Subject: Limerick Generating Station, Units 1 and 2 Information for
Containment Systems Branch (CSB) and Accident Evaluation
Branch (AEB) Regarding SGTS Drawdown

In the reference (1) telecon, Mr. Bell of your staff requested that we provide revised FSAR pages which reflect an increase to the reactor enclosure design inleakage rate from 50 to 100 percent free volume per day and a doubling of the SGTS fan flow during drawdown of the Unit 1 reactor enclosure. In response to that request, I am enclosing draft revised FSAR pages.

The information contained on these draft FSAR changes will be incorporated into the FSAR, exactly as it appears on the attachments, in the revision scheduled for August, 1984.

FIGURE 6.2-52

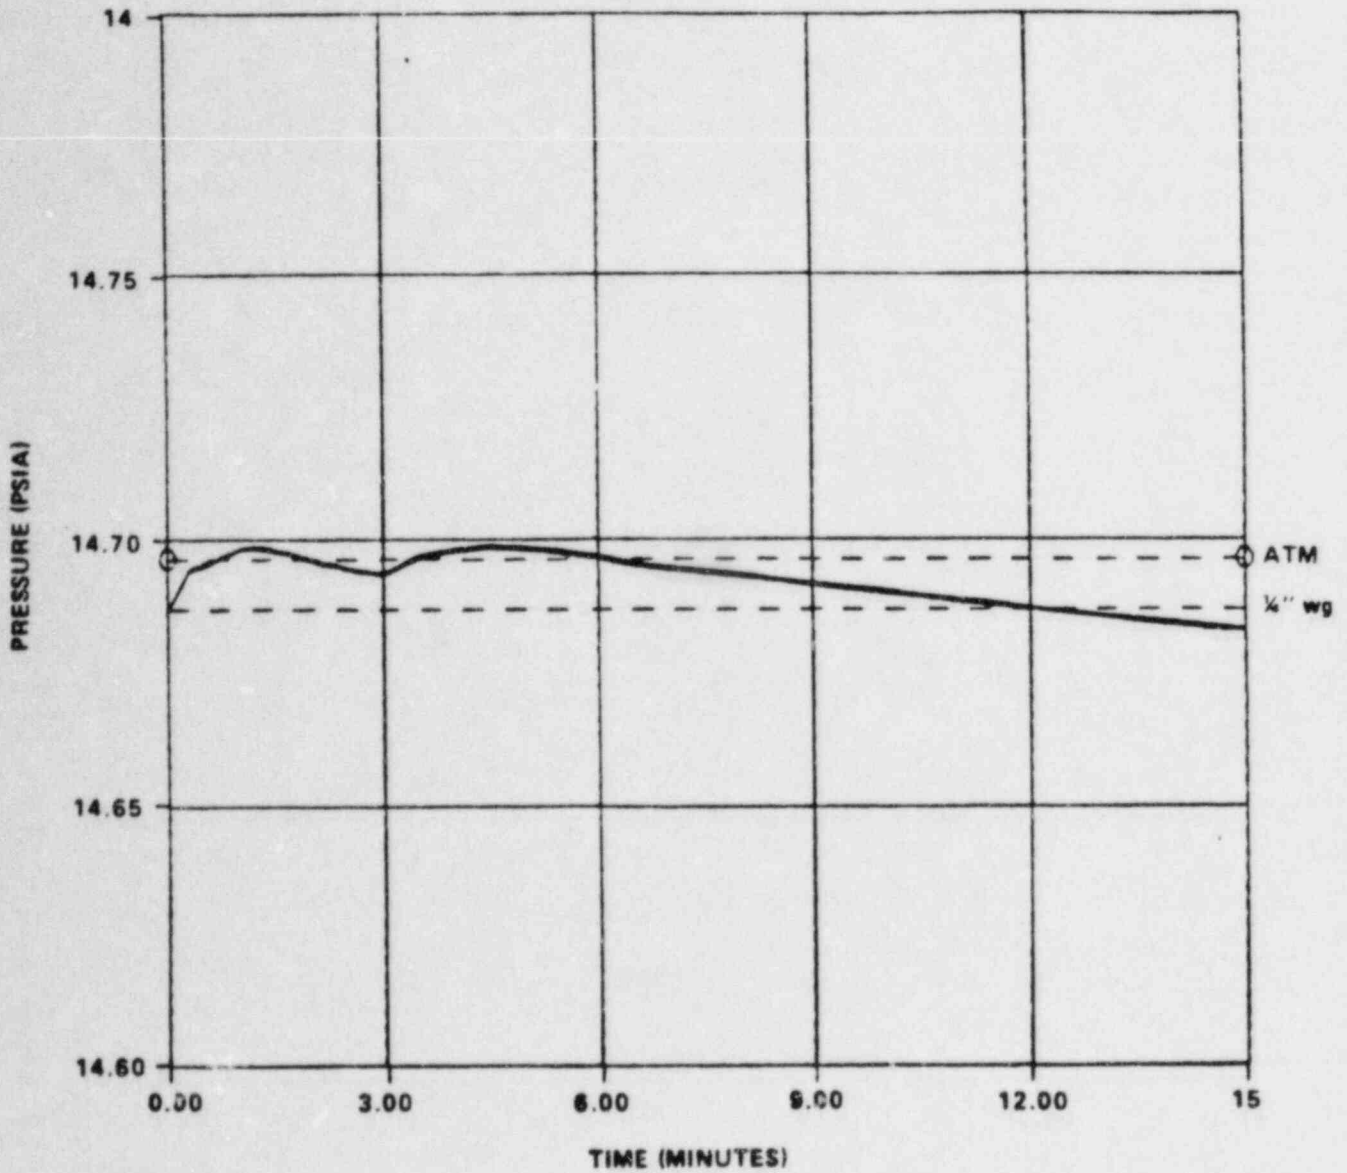
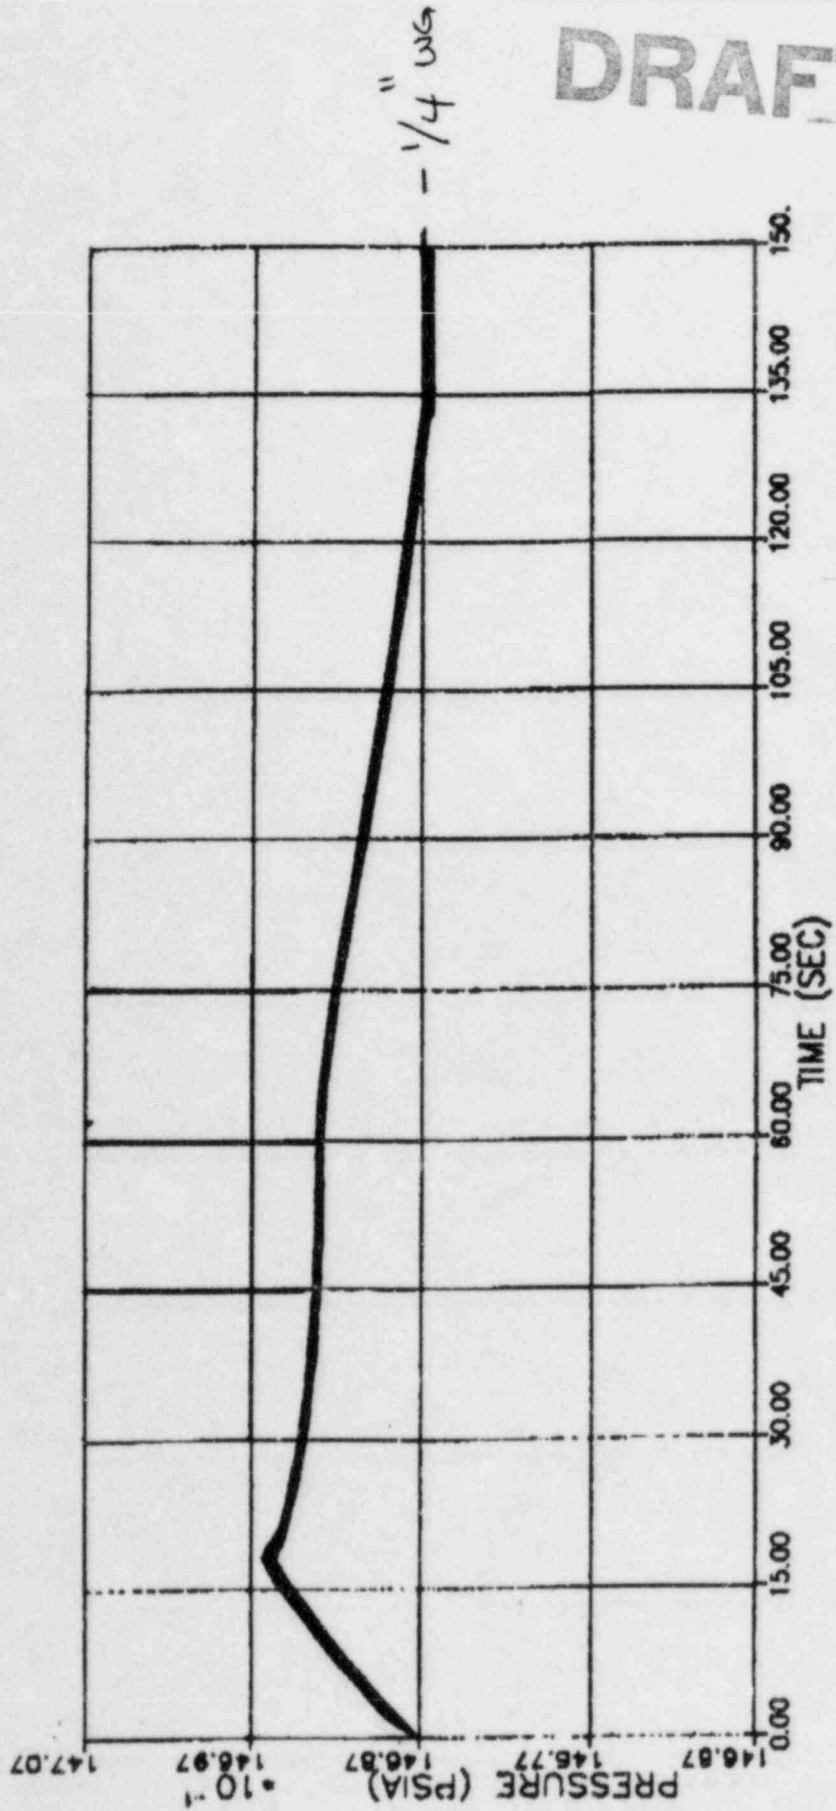
An analysis of the post-LOCA pressure transient in the reactor enclosure was performed. The length of time following isolation signal initiation of the SGTS that the pressure in the secondary containment would exceed minus 0.25 in. wg. is ~~12.5~~ minutes, based on drawing down both units at the same time. 2.25^N

(Figure 6.2-52)

Replace figure
with the attached

based on drawing down ONLY THE UNIT 1 reactor enclosure, which will be the case prior to unit 2 operation. Before unit 2 fuel load, design modifications will be made to ensure a 2.25 minute drawdown during two unit operation.

A MAXIMUM SGTS FLOWRATE OF 2800 CFM WAS USED FOR THE DRAWDOWN ANALYSIS.

AS DISCUSSED IN SECTION 6.5.1.1.1.f, THIS MAXIMUM SGTS FLOWRATE CORRESPONDS TO THE FIRST 3 MINUTES AFTER AN ACCIDENT, WHEN RERS IS NOT YET IN OPERATION.
